Part: SE141-116 / MODULAR COIL WINDING FORM TYPE

Drawing ID: SE141-116

Problem: NON-CONFORMANCE 1

Attachment I: Disposition of NCR # 18715 for MCWF C-2

Non-conformance 1

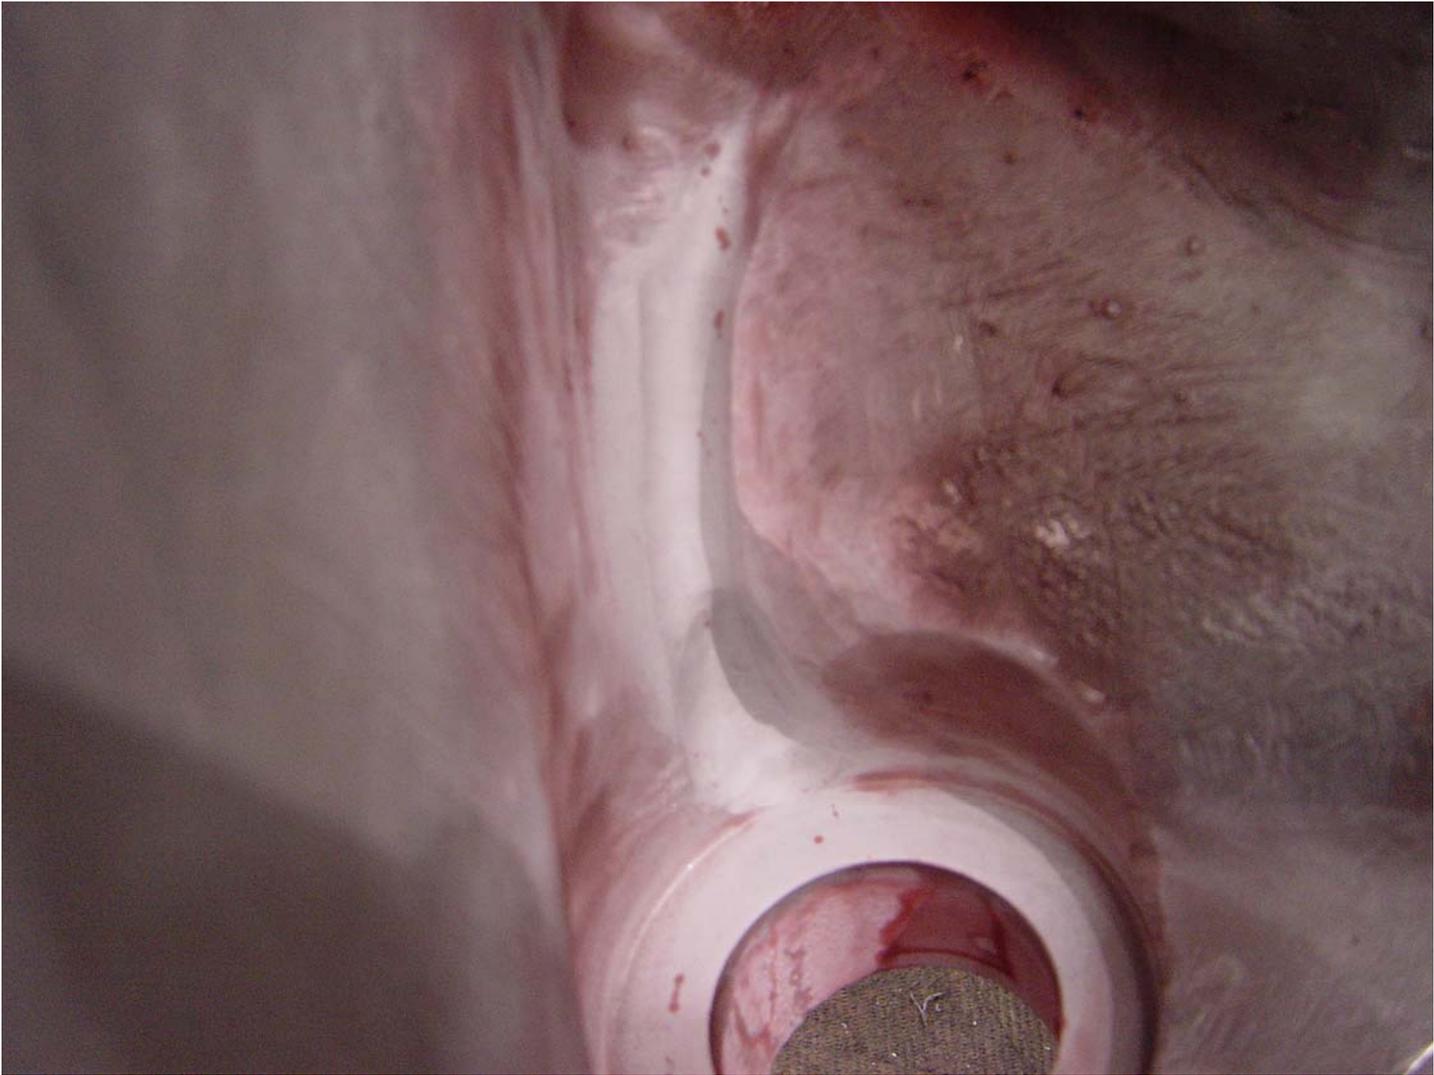
PART IS REJECTED PER ASTM A903/A903M Level I. INDICATION IS V-SHAPED AND IS APPROXIMATELY .450" IN LENGTH ON THE LONGEST LEG (SEE PICTURES). INDICATION IS ON THE THIN SECTION OF THE T, LOCATED BETWEEN HOLES 84 AND 85. SEE ACCOMPANYING PHOTOS.

NCR #1: Disposition: Accept AS IS.

As can be seen in the photos below, the non-conforming linear indication

(in the ground depression) is ~11 mm long. It is located between bolt holes 84 and 85. The stress in this region is ~60 MPa, but it is adjacent to an area where the stress is ~120 MPa.

The recommendation to accept “AS IS” is based on the adequacy of the fracture lifetime with an 11 mm initial flaw in the T with a stress of 60 MPa. The plot below is from an internal NCSX Project Power Point slide set entitled “fracture story-3”. The plot shows that an initial flaw size 3 x 9 mm would meet 4 x life to crack through the T for a stress level of ~180 MPa. The 60 MPa – the stress in the area of this flaw- is well off to the left of the vertical axis of the graph. Based on this, we feel it is reasonable and in the best interest of the project to accept this flaw “as is”.

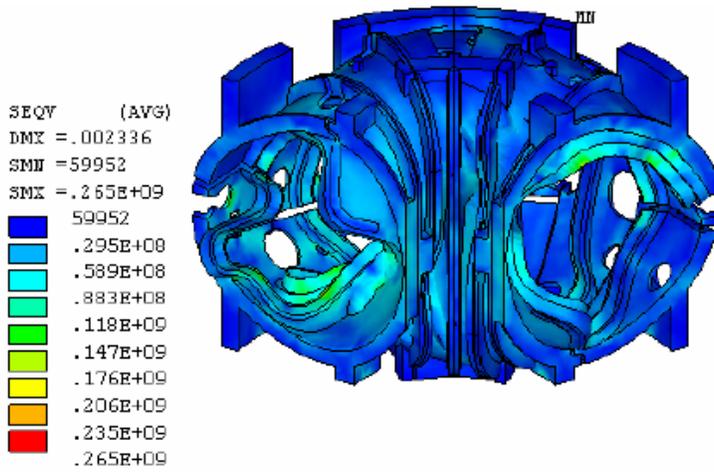
PART IS ALSO REJECTED PER ASTM A903/A903M LEVEL II. INDICATIONS ARE JUST OVER THE ACCEPTABLE SIZE RANGE. SEE ACCOMPANYING PHOTOS.

NCR#2: Disposition: Accept AS IS. This indication is in a region where the stress is low – in the range of 60 MPa (see the figure below – virtually all of the leg region is ~60 MPa). The fatigue curve shown for NCR 1 is for a pre-existing crack to grow through a 3/4” thickness and, as in NCR1, the 60 MPa stress is far to the left of the vertical axis. It is in a heavy overcast area near the region where the leg, shell, and flange all come together; consequently, this indication can be accepted as is. The thickness that the flaw would have to “grow” through is significantly bigger for this flaw: the leg is ~1 3/8” thick; the shell is ~1 3/8” thick; the flange is 1 1/4”
